# Access Compliance Report

## Public Rights-of-Way

### (Pedestrian Signals)

Intersection ID: N/A	Main Street:	Cross Street: N/A	Location: N/A
ADA ID: B1192327FF7D	Signal Type: One Push Button-Non APS	Overall Compliance: No	Severity Score: BTN 1: N/A BTN 2: N/A No BTN: N/A
Codes/Mitigation Info/Possible Solution		Field Measurements/Component Compliance

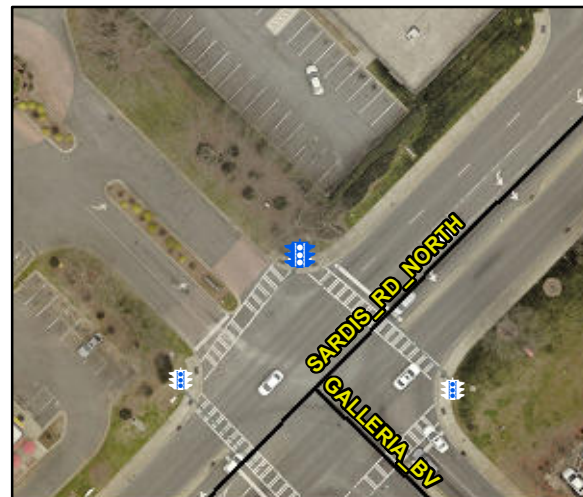
PROW/ADA: R209.1, TMUTCD 4e.08, R404.2, R406.2, R404.7.3

Compliance	Description	Data	Compliance	Description	Data
	Button Count	Button1	N/A	Distant to Additional Button (in)	N/A
	Additional Button Present?	No		Additional Button ID	N/A
N/A	Signal Buttons Required?	N/A	N/A	Additional Ped Posts Required	N/A
	How Many Ped Street Xings?	2		Located In An Island/Median?	No
N/A	B 1 Sign Present?	Yes	N/A	B 2 Sign Present?	N/A
No	B 1 Sign Purpose?	No	N/A	B 2 Sign Purpose?	N/A
Yes	B 1 Sign Lettering & Contrast?	Yes	N/A	B 2 Sign Lettering & Contrast?	N/A
No	B 1 Parallel To XWalk?	No	N/A	B 2 Parallel To XWalk?	N/A
Yes	B 1 PAR to Button?	Yes	N/A	B 2 PAR to Button?	N/A
Yes	B 1 PAR to XWalk?	Yes	N/A	B 2 PAR to XWalk?	N/A
Yes	B 1 Clear Floor Space?	Yes	N/A	B 2 Clear Floor Space?	N/A
N/A	B 1 FWD Approach?	Yes	N/A	B 2 FWD Approach?	N/A
N/A	B 1 FWD Approach Constrained?	No	N/A	B 2 FWD Approach Constrained?	N/A
No	B 1 FWD Approach Reach (in)	11.0	N/A	B 2 FWD Approach Reach (in)	N/A

N/A	B 1 FWD Approach Width (in)	N/A	N/A	B 2 FWD Approach Width (in)	N/A
N/A	B 1 FWD Approach Obstruction?	Yes	N/A	B 2 FWD Approach Obstruction?	N/A
N/A	B 1 FWD Approach Obstruction Dist (in)	2.0	N/A	B 2 FWD Approach ObstructionDist (in)	N/A
N/A	B 1 PARA Approach?	Yes	N/A	B 2 PARA Approach?	N/A
N/A	B 1 PARA Approach Constrained?	No	N/A	B 2 PARA Approach Constrained?	N/A
No	B 1 PARA Approach Reach (in)	11.0	N/A	B 2 PARA Approach Reach (in)	N/A
N/A	B 1 PARA Approach Width (in)	N/A	N/A	B 2 PARA Approach Width (in)	N/A
N/A	B 1 PARA Approach Obstruction?	Yes	N/A	B 2 PARA Approach Obstruction?	N/A
N/A	B 1 PARA Approach Obstruction Dist (in)	2.0	N/A	B 2 PARA Approach ObstructionDist (in)	N/A
Yes	B 1 Clear Floor Space Slope (%)	1.4	N/A	B 2 Clear Floor Space Slope (%)	N/A
No	B 1 Clear Floor Space XSlope (%)	2.5	N/A	B 2 Clear Floor Space XSlope (%)	N/A
N/A	B 1 PAR Slope (%)	5.1	N/A	B 2 PAR Slope (%)	N/A
Yes	B 1 Height (in)	39.0	N/A	B 2 Height (in)	N/A

Yes	B 1 Clear Xing Direction?	ClearlyMarked	N/A	B 2 Clear Xing Direction?	N/A
	B 1 Crossing Direction	To SE		B 2 Crossing Direction	N/A
Yes	B 1 DistanceTo XWalk (in)	0.0	N/A	B 2 DistanceTo XWalk (in)	N/A
No	B 1 DistanceTo Curb (in)	98.0	N/A	B 2 DistanceTo Curb (in)	N/A
Yes	B 1 Diameter (in)	2.0	N/A	B 2 Diameter (in)	N/A

Possible Solutions: Replace Signal Push Button With APS Button on New Post. Remove & Replace Sign.
